INDESIT company

Model type:
AXD100EU

Commercial code:
F027789

n1040277: Modification of pressure switch protection and tube

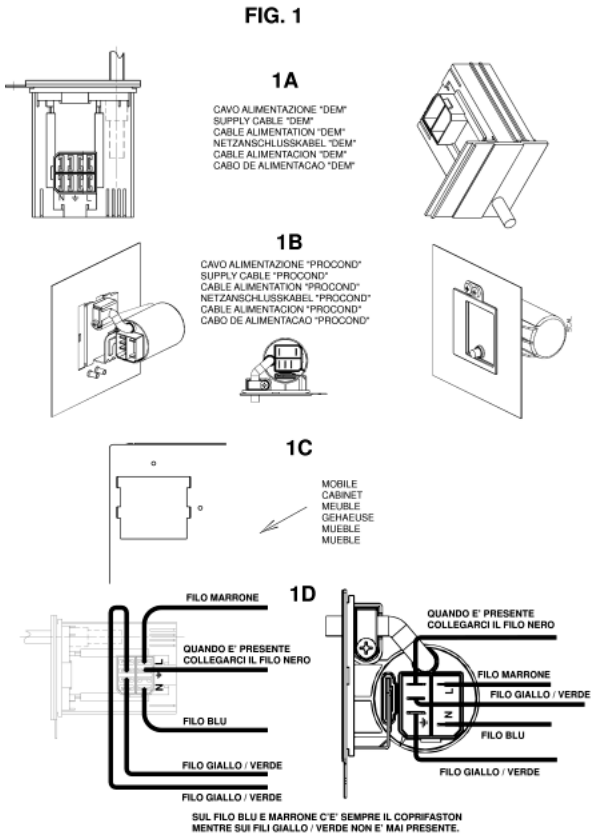
From serial no. 21104.0001, all washing machine models produced in the Brembate factory and relevant to this note have been

equipped with a new pressure switch tube 041785 replacing 051552, a new pressure switch tube protection 019755 replacing 078221 and two plastic clamps replacing terminals 051541.
premodification parts will be managed until stocks run out and are interchangeable with the new ones only if used altogether.

n1040285: Modified shock absorber bracket - Brembate plant

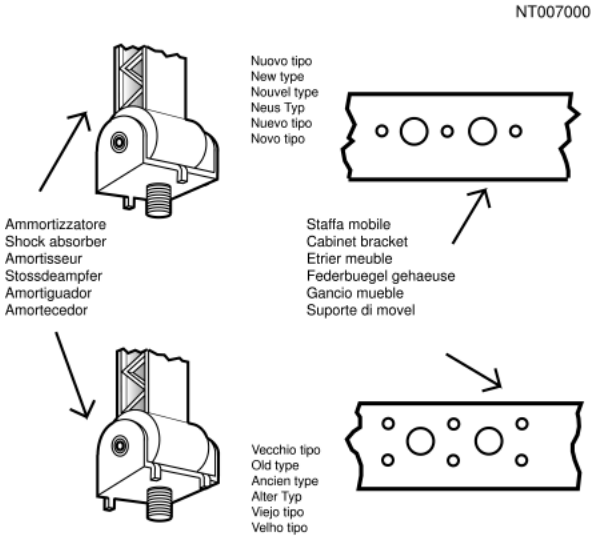
From the registration no. 30127.0001, the washing machines and Washer-Dryers produced in the Brembate factory Plant, have used modified shock absorbers with the bracket that fixes onto the cabinet.
The codes for the new shock absorbers are:
Code 093648 - Shock absorber 120N-2PIN;
Code 093649 - Shock absorber 100N-2PIN;
The modification also involved the cabinets in the fixing area that for the shock absorbers represent a different type of slotting (see enclosed figure).
To avoid the proliferation of the codes, the modified cabinets are handled with the same SAT code as the pre-modification, when replacing the cabinet you will need to check the registration number of the appliance.
In order to perform a proper task the intervention of the cabinet replacement it is recommended, that at least in the initial phase, to keep both the combination of shock absorbers in stock. The shock absorbers code 081705 (120N-4PIN) and 082327 (100N-4PIN) will continue to be normally handled.

The codes for the new cabinets are: 092794 – 091748 – 091758 – 091742 – 091756 – 091754 – 091749 – 091752 – 090931 – 090187 – 089649 – 083287.
